## SAF CBX40 Trailer Air Suspensions

### Product Change Notice for the MAX-VALVE™ Ride Height Control Valve

Effective with shipments September 2012

#### MAX-VALVE™

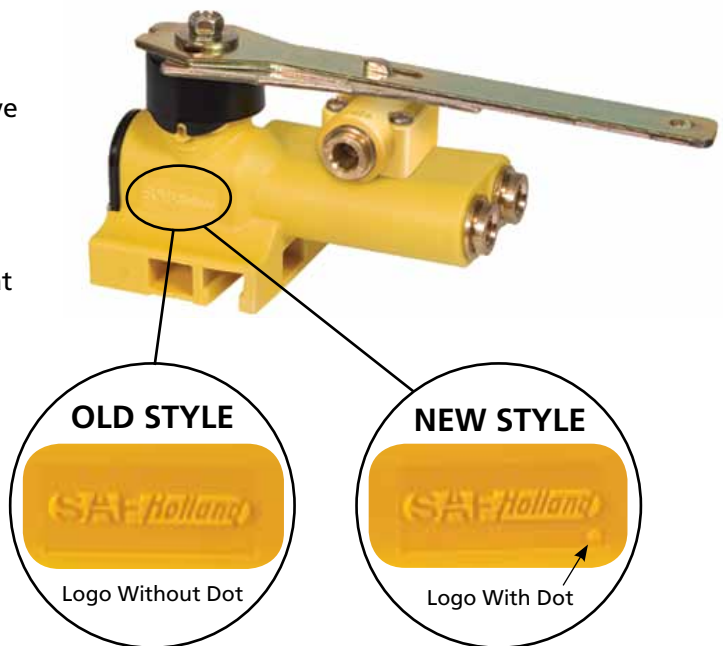
A product update has been made to the MAX-VALVE™ height control valve used on the CBX40 trailer air suspension system. In our ongoing efforts to give the industry the highest quality product available, we have increased the air flow on the fill side of the valve, improving the time required to reach ride height.

New style MAX-VALVE™ height control valves can be identified by the dot that is located near the logo that is molded into the valve body.

As a result of this product update, the new style MAX-VALVE™ height control valves have been assigned a new part number ( see table below).
